## S E R V I C E N O T E

**E2411C Preprocessor Interface****Serial Numbers:** 3319A00000 / 3319A00169**Correct PLL Lock Problem****To Be Performed By:** Agilent-Qualified Personnel or Customers with adequate SMT and ESD repair facilities.**Duplicate Service Notes:** None**Parts Required:**

Clock PLL Does Not Lock at Upper Specified Frequencies

**CORRECT**

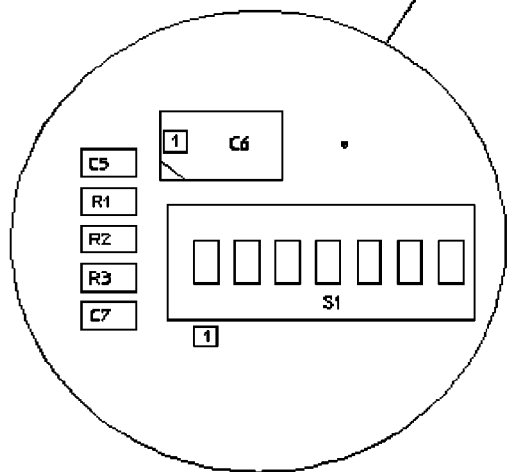
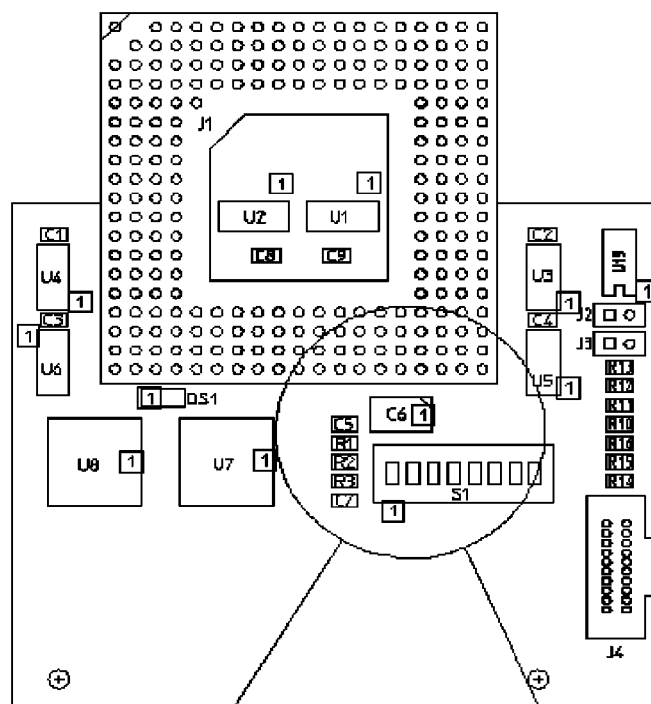
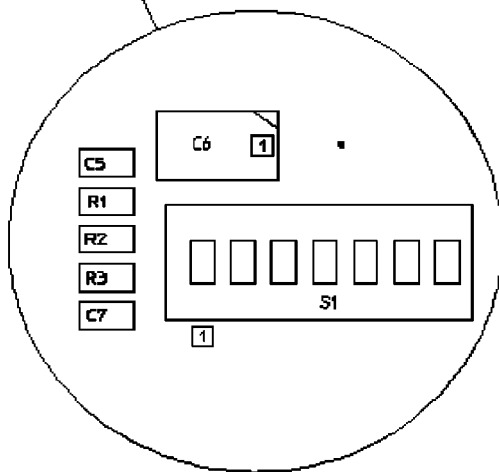
Due to an error on the silk-screened polarity marking for C6 on the preprocessor board, C6 was loaded backwards. The leakage current caused by the reversed polarity on C6, lowers the upper operating frequency of the PLL. The upper frequency cutoff is inversely proportional to the length of time the reverse voltage was applied to the capacitor.

1. Loosen the ribbon cable retainer screws.
2. Slide the clear plastic ESD cover from under the cable retainer screws.
3. Locate C6 (see figure 1)
4. Unsolder and discard this capacitor.
5. Install a new capacitor (Part Number 0180-4116) with the positive contact opposite the locator dot (see the "CORRECT" insert in figure 1).
6. Slide the loose end of the clear plastic ESD cover under the cable retainer and tighten the screws.

To correct this problem, the reversed capacitor must be replaced by a new capacitor and installed with the correct polarity. Just reversing the original capacitor is not an acceptable solution because of the permanent damage to the capacitor while it was operating with reversed voltage applied.
